UNITED STATES PATENT AND TRADEMARK OFFICE

APPLICATION NO.	FILING DATE	FIRST NAMED INVENTOR	ATTORNEY DOCKET NO.	CONFIRMATION NO.
10/077,927	02/20/2002	Hiroaki Nakaminami	1248-0578P-SP	6989

Office Action Summary	Application No. 10/077,927	Applicant(s) NAKAMINAMI ET AL.	
	Examiner Tarifur R Chowdhury	Art Unit 2871

FIG. 3

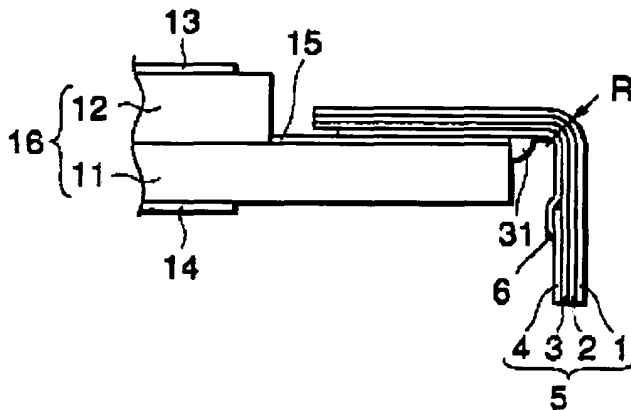
12. Nakamura discloses (col. 1, line 58 – col. 2, line 22) and shows in Fig. 3, a display module, which includes a display panel (16) provided with external connection terminals and a flexible wire board (5) having a wire pattern (3) on a base material (1),

terminals of the wire pattern of the flexible wire board and the external connection terminals of the display panel being bonded using an anisotropic conductive adhesive (6), the flexible wire board (5) having an insulating protective layer (4) for protecting the wire pattern.

Nakamura differs from the claimed invention because he does not explicitly

disclose that the insulating protective layer of the flexible wire board is extended inside the display panel.

As to claims 3, 4 and 13-16, Nakamura clearly shows in Fig. 3 that the anisotropic conductive adhesive (6) is extended to protrude from the display panel (16). Nakamura also discloses that the base film (1) of the flexible wire board has a thickness of 25 μm (not more than 40, and the insulating protective layer (4) has a thickness of 25 μm (not more than 40 μm), and the insulating protective layer is bonded onto the base material including the wire pattern (3) by thermocompression bonding (col. 4, lines 29-37; 52-54).

As to claims 5 and 6, Nakamura also shows in Fig. 3 that a corner of the display panel (16), which faces an inner side of a bent portion of the flexible wire board (5) in a bent state, is formed into a chamfered portion. Further, as explained above since Fujita teaches that extending the insulating protective layer of the flexible wire board inside the display panel is advantageous since it prevents any short-circuiting from occurring to the leads due to the foreign objects adhering thereto and that the chamfered portion is formed at the periphery of the substrate of the display panel, it would have at least been obvious that the insulating protective layer of the flexible wire board is extended beyond the chamfered portion.

As to claims 7-9, Nakamura also shows in Fig. 3 that the flexible wire board (5) is also bonded onto the chamfered portion and a side of the display panel by using anisotropic conductive adhesive (31).

Fig. 3D

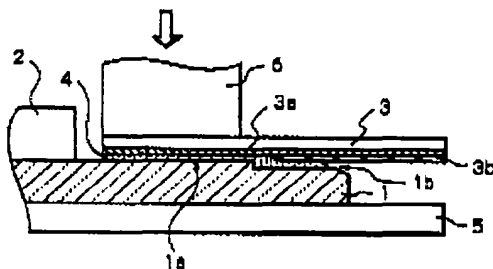
8. Fujita discloses and shows in Fig. 3D, a display module, which includes a display panel (2) provided with external connection terminals and a flexible wire board (3) having a wire pattern (3a) on a base material (3), terminals of the wire pattern of the flexible wire board and the external connection terminals of the display panel being bonded using an anisotropic conductive adhesive (4), the flexible wire board having an insulating protective layer (3b) for protecting the wire pattern, wherein:

the insulating protective layer (3b) of the flexible wire board is extended inside the display panel while having the flexible wire board connected to the display panel.

Fujita discloses a display module which includes a display panel (2) and a flexible wire board (3) having a wire pattern (3a) and an insulating protecting layer (3b) for protecting the wire pattern wherein the insulating protective layer extends inside the display panel (Fig. 3D). Fujita also discloses that since the insulating protecting layer extends inside the display panel and thus protect the leads of the flexible wire board from being exposed to outside, any short-circuiting can be reliably prevented from occurring to the leads due to the foreign objects adhering thereto (col. 3, lines 20-30; col. 4, lines 6-11; col. 5, lines 59-63).

Fujita is evidence that ordinary workers in the art would find a reason, suggestion or motivation to extend the insulating protective layer inside the display panel.

Therefore, it would have been obvious to one of ordinary skill in the art at the time of the invention was made to modify the display module of Nakamura by extending the insulating protective layer of the flexible wire board inside the display panel so that the leads of the flexible wire board is protected from being exposed to the outside and

thus any short-circuiting can be reliably prevented from occurring to the leads due to the foreign objects adhering thereto, as per the teachings of Fujita.
